Subject: Cabot Reading Site, Reading, Pennsylvania (License No. SMC-1562)
Radiological Assessment and Decommissioning Plan
Rip-Rap Cover Design Modifications

CABOT
Reading, Pennsylvania Slag Pile Site
Revision 3 Replacement Pages Instructions

**Revision 3
June 2005**

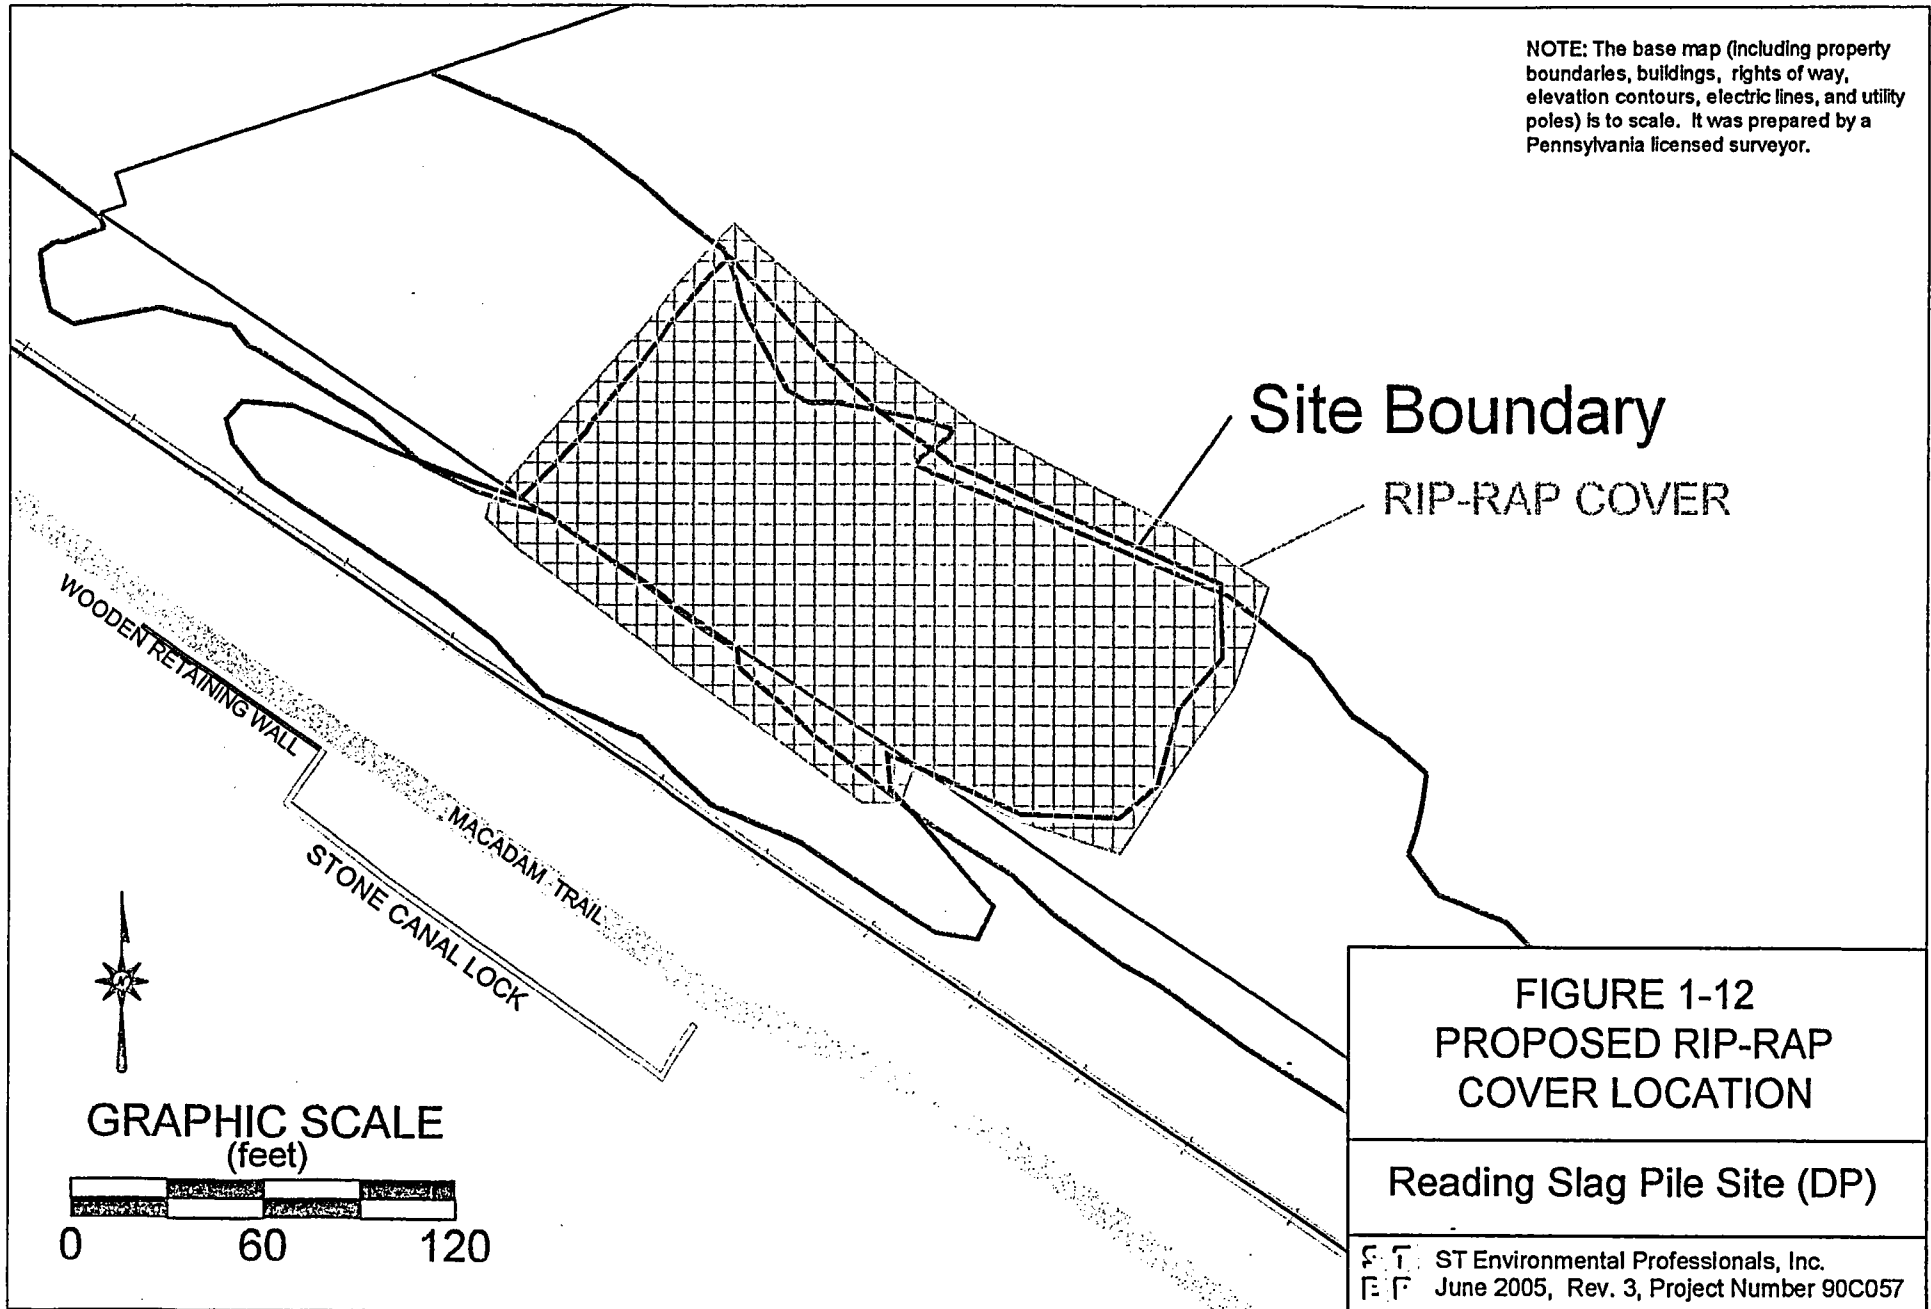
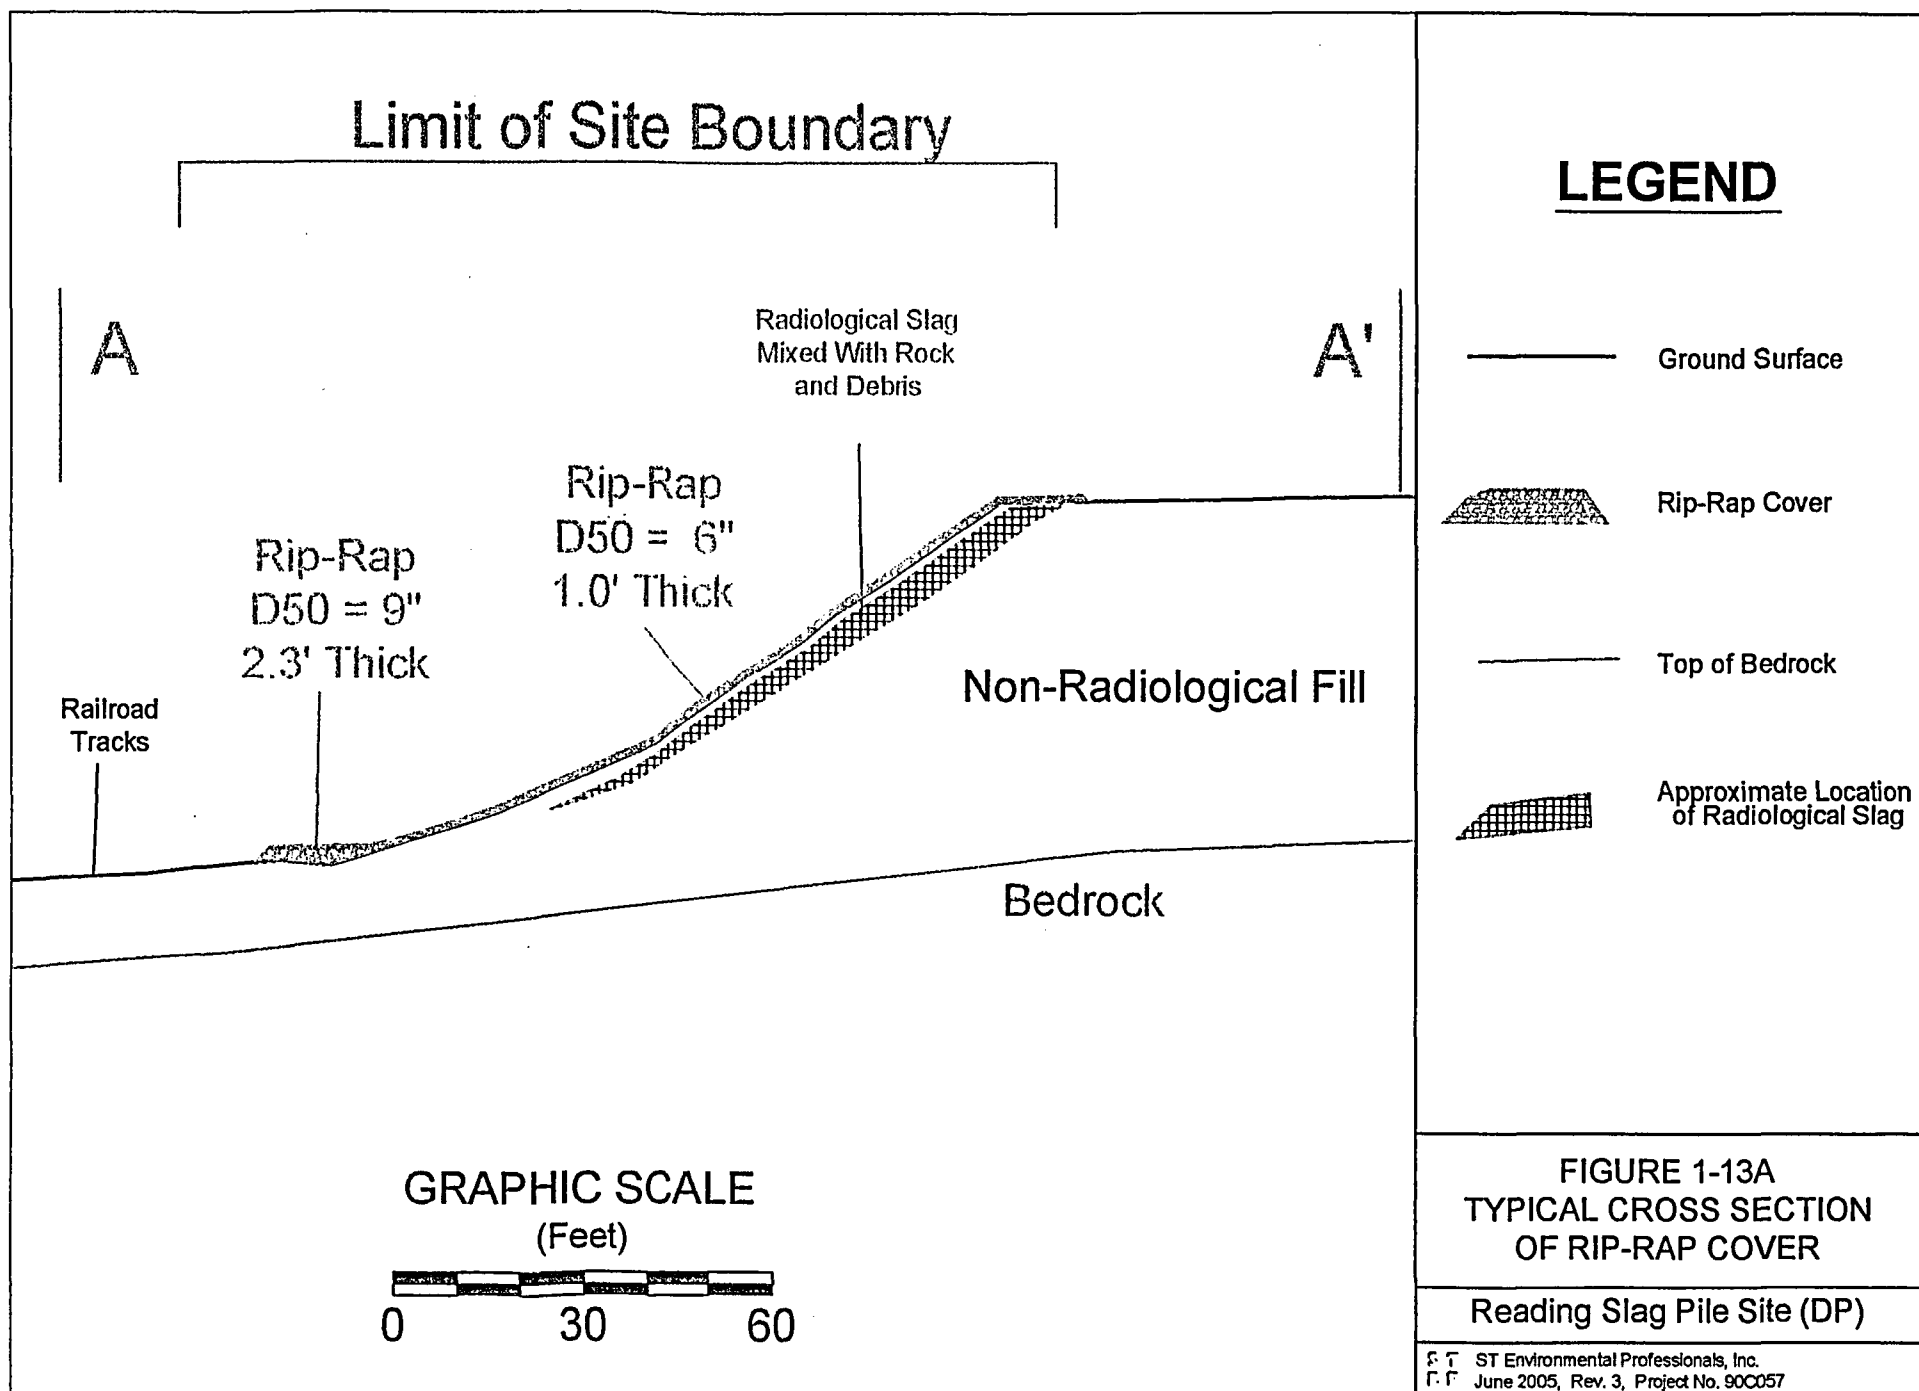
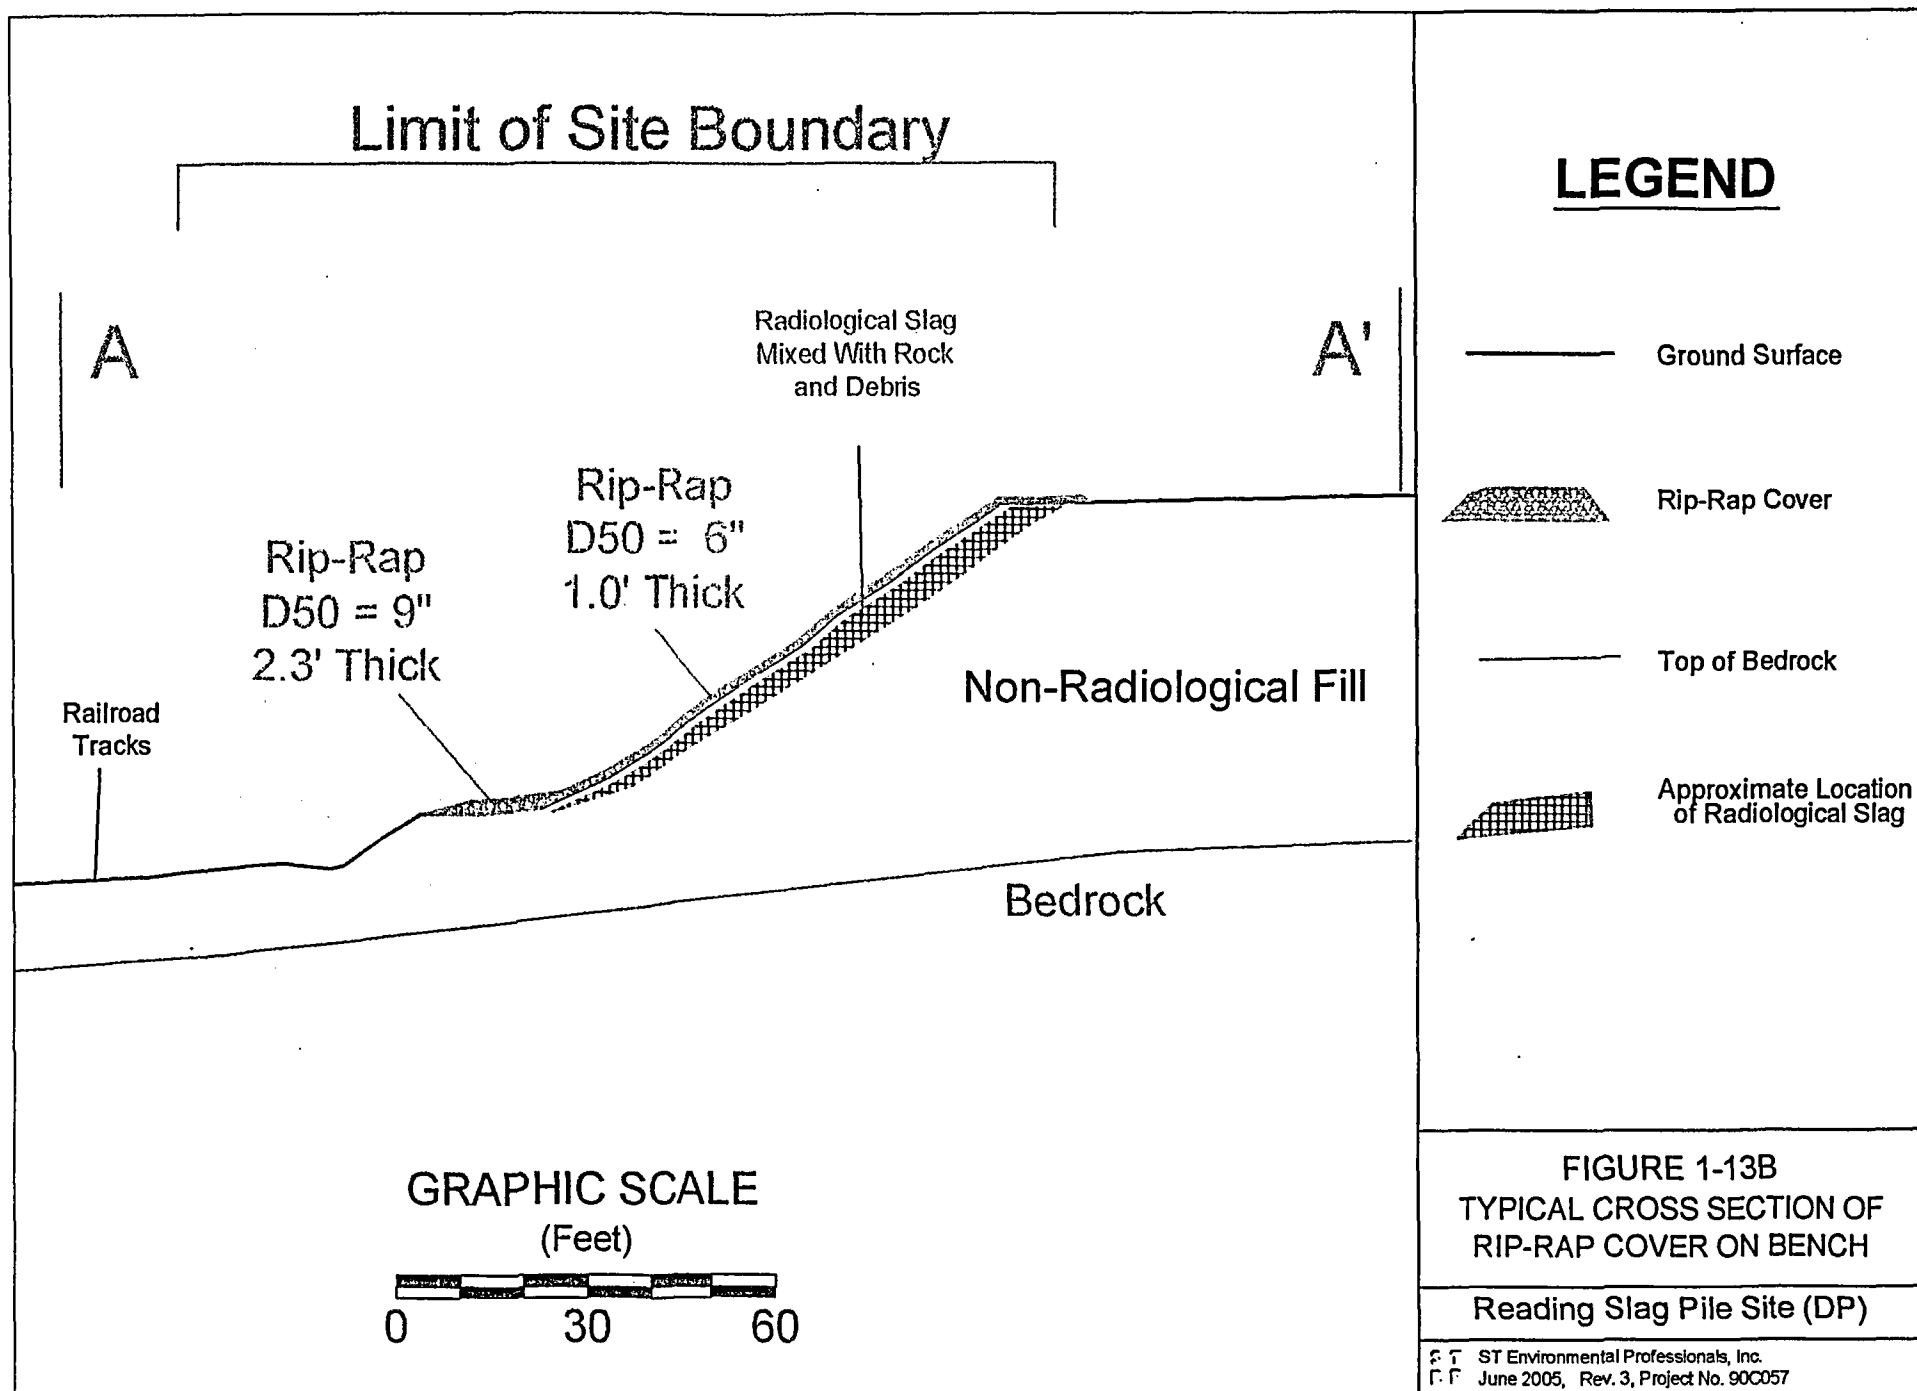
The participants in the meeting concluded that the planned extension of River Road to provide improved access to the Dana property would benefit from a thinner and smaller area of rip-rap in the River Road right-of-way (ROW). To evaluate the feasibility of changing the rip-rap design, Cabot inspected the ACC property. The inspection found that the upper portion of the ACC property drains to the south and east, away from the top of the slope containing the slag. The rip-rap design calculations provided in reference 1 conservatively assumed that the area within 500 feet of the slope drained on to the slag pile. Revised calculations, using the actual topography, resulted in a reduction of the required rip-rap rock size, thickness and width of the rip-rap base extending into the ROW. In addition, the calculations indicated that the rip-rap only needs to extend to the top of the topographic bench in the southern portion of the slope. The revised design, consistent with the calculations, remains compliant with NUREG-1623.

The rip-rap cover design was performed by an experienced geotechnical engineering firm using the guidelines in NUREG-1623. The detailed calculations and procedures for installation are contained in Appendix E. On the slope and top edge of the pile, the cover will consist of a 1.0 foot thick layer of durable rock with an average size of approximately 6" ($D_{50}=6''$). At the base of the slope, a 2.3-foot thick layer of $D_{50}=9''$ durable rock will extend 11 feet from the slope to form a base to anchor the slope. The rip-rap cover is depicted in plan view on Figure 1-12 and cross section in Figures 1-13A and 1-13B.

The rip-rap cover on the slope and top edge will consist of a 1.0 foot thick layer of durable rock sized $D_{50}=6''$ (USA number R-4 rip-rap). This exceeds the size criteria calculated using NUREG-1623 methods of $D_{50} = 1.3$ for the slope. An apron of rip-rap will be placed extending 11 feet out from the toe of the slope to anchor the rip-rap cover. This will eliminate the need to excavate slag at the toe of the slope. The apron will consist of USA number R-5 rip-rap ($D_{50} = 9''$). This exceeds the design calculation of $D_{50} = 7.2''$. The apron will be 2.3-feet thick to facilitate proper placement of the large size rip-rap. Additional design details are provided in the Decommissioning Plan (STEP, 2005). Figure 1-3 depicts the location and extent of the proposed rip-rap cover. Figure 3-2 depicts the typical cross section.
